UNITED STATES PATENT AND TRADEMARK OFFICE

APPLICATION NO.	FILING DATE	FIRST NAMED INVENTOR	ATTORNEY DOCKET NO.	CONFIRMATION NO.
10/603,712	06/25/2003	Minjoo L. Lee	MIT.9889	3454
7590	02/22/2005		EXAMINER	
Samuels, Gauthier & Stevens LLP Suite 3300 225 Franklin Street Boston, MA 02110			WILSON, ALLAN R	
			ART UNIT	PAPER NUMBER
			2815

Office Action Summary

DETAILED ACTION***Drawings***

FIG. 2A

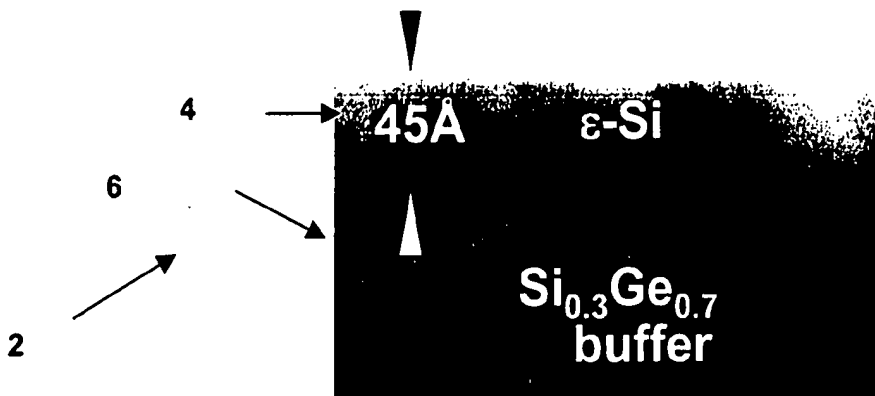
The drawings are objected to under 37 CFR 1.83(a). The drawings must show every feature of the invention specified in the claims. Therefore, the layers forming the MOSFET, PMOS, NMOS and CMOS must be shown or the feature(s) canceled from the claim(s). The drawings are too dark to show the details. No new matter should be entered.

The argument that FIGs. 2A-2B and 3A-3B illustrate a MOSFET is not persuasive. The drawing are too dark to see the construction or elements. Attached are copies of FIGs. 2A-2B and 3A-3B (Exhibit A) that show what was scanned.

Corrected drawing sheets in compliance with 37 CFR 1.121(d) are required in reply to the Office action to avoid abandonment of the application. Any amended replacement drawing sheet should include all of the figures appearing on the immediate prior version of the sheet, even if only one figure is being amended. The figure or figure number of an amended drawing should not be labeled as "amended." If a drawing figure is to be canceled, the appropriate figure must be removed from the replacement sheet, and where necessary, the remaining figures must be renumbered and appropriate changes made to the brief description of the several views of the drawings for consistency. Additional replacement sheets may be necessary to show the renumbering of the remaining figures. The replacement sheet(s) should be labeled "Replacement Sheet" in the page header (as per 37 CFR 1.84(c)) so as not to obstruct any portion of the drawing figures. If the changes are not accepted by the examiner, the applicant will be notified and informed of any required corrective action in the next Office action. The objection to the drawings will not be held in abeyance.
